AERONAUTICAL CHARTING FORUM
Instrument Procedures Group
Meeting 12-01 – April 24, 2012
HISTORY RECORD

FAA Control # 12-01-301

Subject: Publishing a Vertical Descent Angle (VDA) with 34:1 Surface Penetrations in the Visual Segment (*Also includes Issue 13-01-309 - LP Procedure Cancelled Because of VDA Not Being Charted*).

**ORDER 8260.3, VOLUME 1, VISUAL PORTION OF FINAL
PENETRATIONS:**

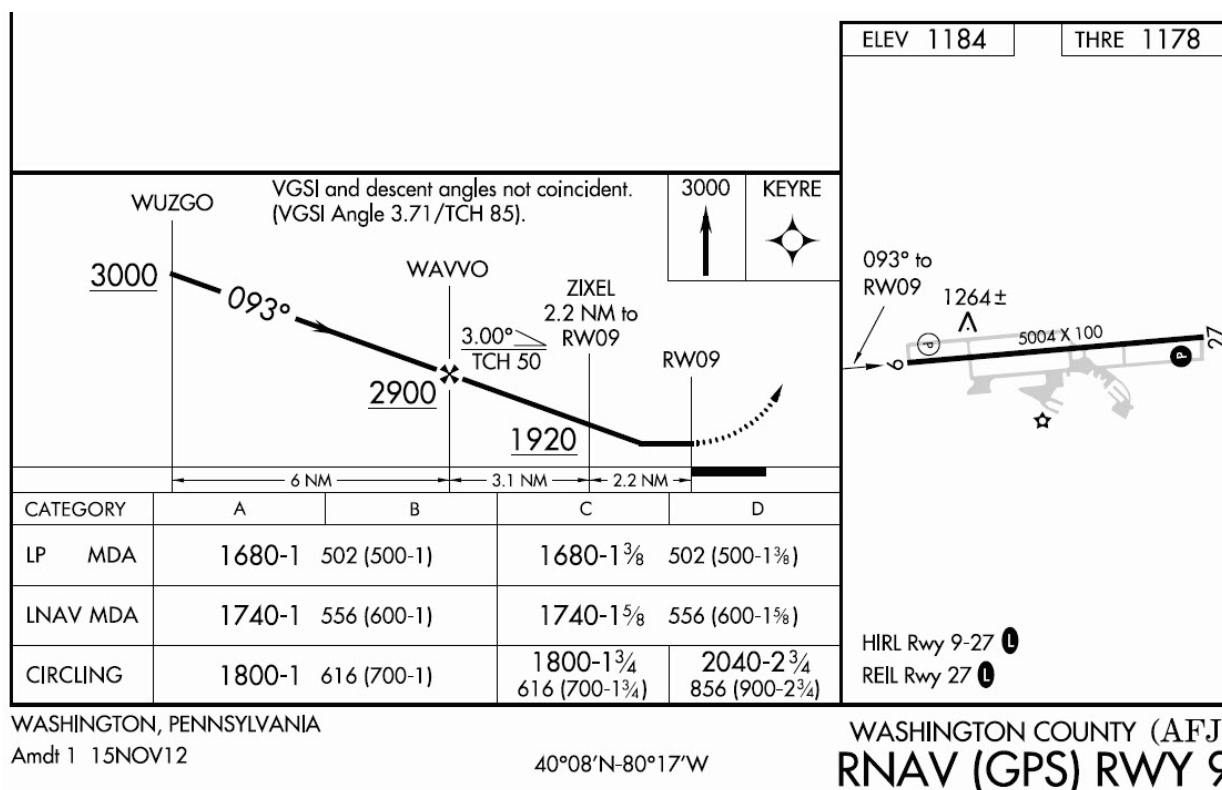
I called the Quality Advisor involved in the discussion to make sure I understood what was going on. He confirmed that the LP could not be published because it could not be coded with a VDA of 0 (zero). He indicated that the 0 was required to prevent advisory vertical guidance on the procedure.

I have several issues with this. The purpose for LP procedures is to provide a lower MDA than permitted by the LNAV where the smaller OCS footprint allows. It is only used when a vertically guided procedure isn't appropriate for the runway. Although a Constant Angle Non Precision Approach (CANPA) may be desirable, it is not always available as an option on all NPA procedures. The advisory glidepath provided by some manufacturers' GPS units is only permitted to be used during the descent to the MDA and not below it. It is my understanding that regardless whether a VDA is published or not, advisory vertical guidance may be provided, in that if the 8260 doesn't provide the data for the advisory glidepath, the manufacturer may calculate one. Therefore, setting the VDA to 0 in the database doesn't necessarily eliminate the advisory glidepath from the database. Because of the coding issue described by the Quality Advisor, the LP procedure is eliminated. It is ironic that the unintended consequence is that the LNAV will end up with an advisory glidepath, but if it is coded in the database it will not generate advisory guidance, at least in the Garmin units. This is because, the LP procedure in the Garmin units don't support advisory vertical guidance under any circumstance whenever LP is the highest service level coded for the approach, regardless if the integrity at the time of the approach supports LP or LNAV. My understanding of the ACF issue dealing with VDA was only to affect whether or not the VDA would appear on the chart and there was to be a note added to the effect "Descent Angle NA". This situation ends up being a 'catch 22', if the runway doesn't qualify for vertical guidance, and flight testing indicates that CANPA is not an option, it doesn't qualify for LP, and when a LP is coded it doesn't have advisory vertical guidance, but if only a LNAV is coded, it does have advisory vertical guidance.

Recommendations: The database coding of LP procedures should be permitted even when the VDA is not charted. Being able to fly a procedure with CANPA should not be a requirement for a NPA.
